# Sub Regional RTEP Committee PJM South

November 18, 2020

# Scope Change

**Existing b3161 Scope Modification**

**Original Solution: (Old)**

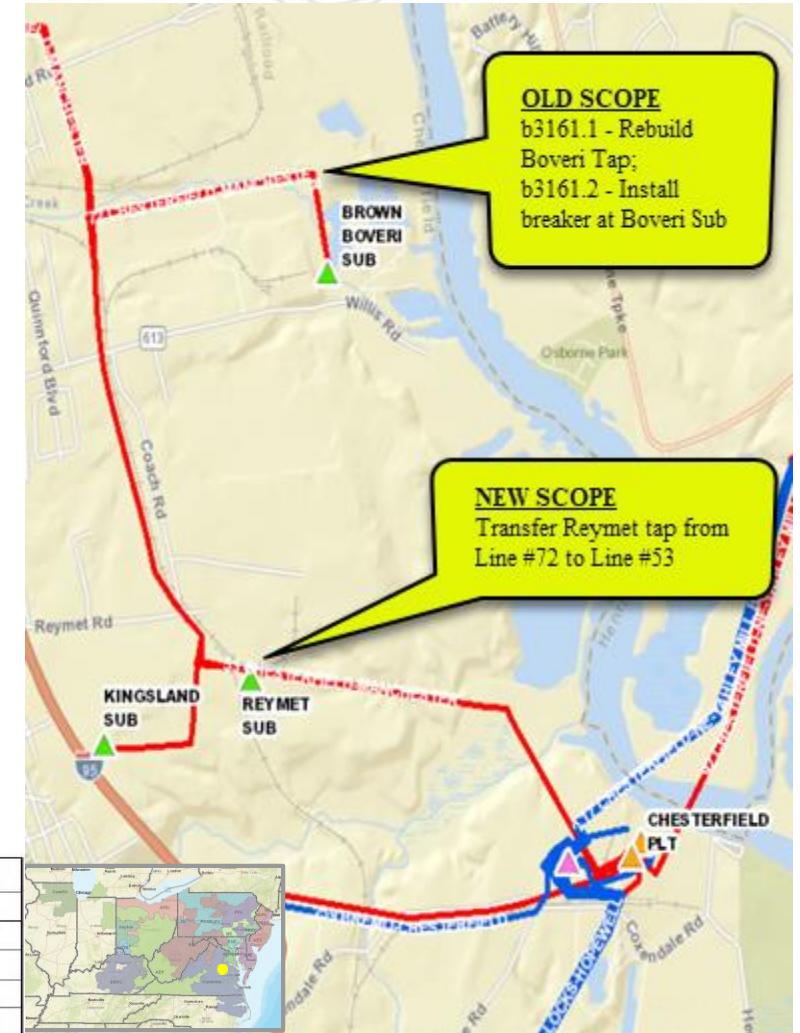
**Problem Statement:** 115kV Line #72 (Chesterfield to Plaza) exceeds the Company’s limitation of serving 4 tapped facilities on one transmission line. The line serves 5 tap stations: National Cylinder Gas, Bellwood, Brown Boveri, Kingsland, and Reymet. Also, the tap line serving Brown Boveri, built in the 1970’s with a length of 1.1 miles, does not meet the company’s requirement of a terminal station for tap lines longer than one mile.

Split Line #72 by rebuilding the Brown Boveri tap line as double circuit loop in-and-out of the station. **(b3161.1)**

Install a 115kV breaker at the station. Site expansion is required to accommodate the new layout. **(b3161.2)**
